DUNES CLUB #1 PUMP STATION

Bid #19 80023

ADDENDUM NO. 4 – September 07, 2018

Connections for Proposed & Temporary
Force Main Operations

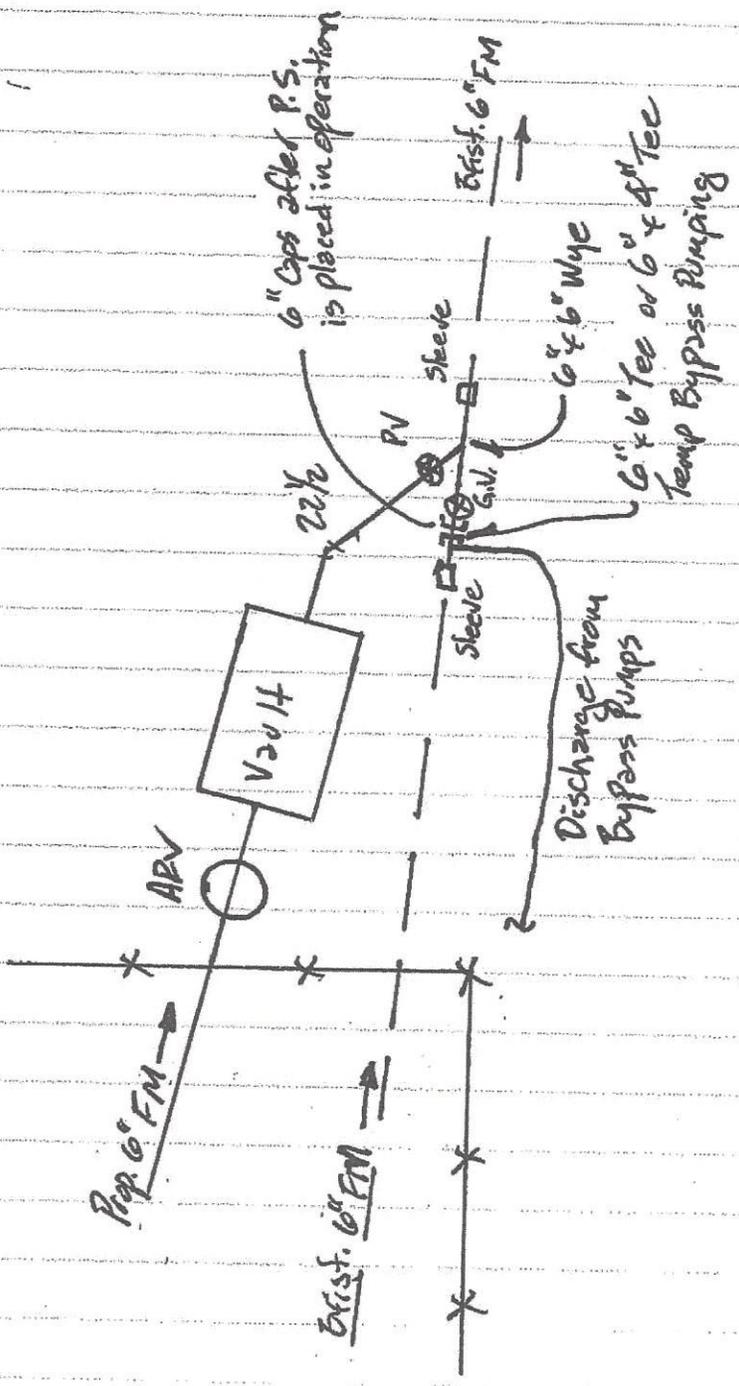
- 1.0 What is procedure for pretesting the pump station and new bypass pump with regards to a drawdown test? I think we will need to be connected to the existing 6" FM in order to do these and if so then the connection would need to be modified to merge new and existing operations simultaneously. We have attached a basic sketch for this and request your approval or comments as a possible solution for this issue?

- 2.0 Can the Meter Vault location be shifted to miss the existing 6" FM as shown on the attached sketch? The current location shown is over the existing 6" FM.

- 3.0 Can we configure a temporary connection for the temporary bypass pumps to the existing 6" FM as shown on attached sketch?

Response - Yes, the contractor will be required to make an existing force main connection as the attached sketch shows in order to pre-test the pump station. The attached sketch is an acceptable method but may change some depending on the locations of the existing and proposed equipment.

Response - Yes the meter vault can be shifted around on the site as needed to miss the existing 6" force main or any other obstructions.

Response - Yes, that would be an acceptable method.
